**Lots Rd, London, SW10 0RN**  
**Planning Portal Ref. PP-14121515**  
**RBKC ref. PP/25/04416**  
**LBHF ref. TBC**

On behalf of our clients Mount Anvil (Lots Road) LLP we are writing to submit minor updates to the Lots Road planning application that was submitted on 21st July 2025.

### **Schedule of Proposed Amendments**

*The red line site boundary in the northern portion of Lots Road South adjacent to Heatherley School of Fine Art as submitted (left) and as amended (right).*

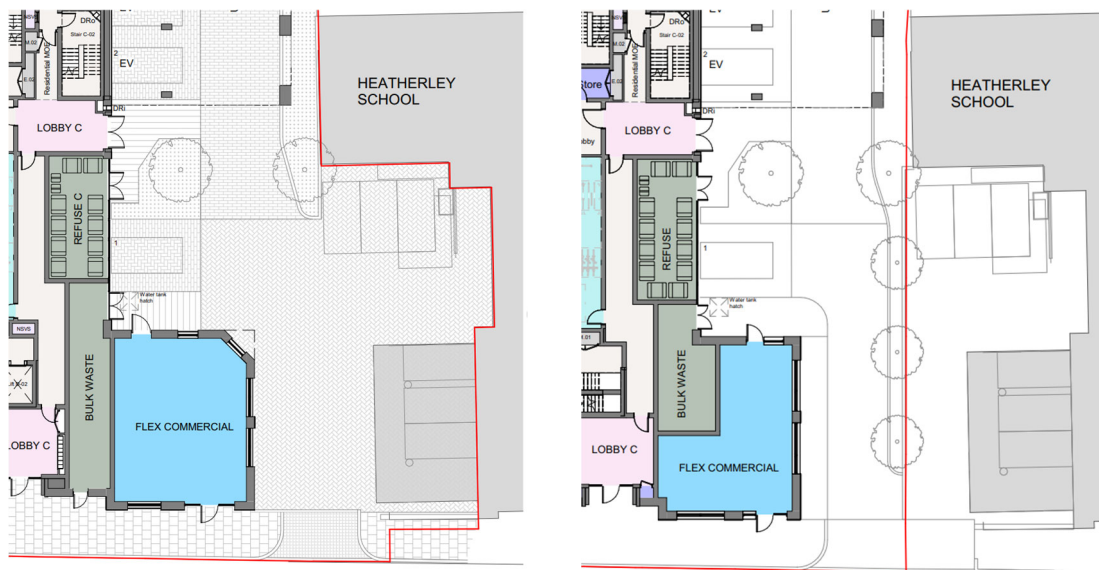
The red line has been amended to remove the land under the ownership of Heatherley School of Fine Art and to reflect the updated access arrangements.
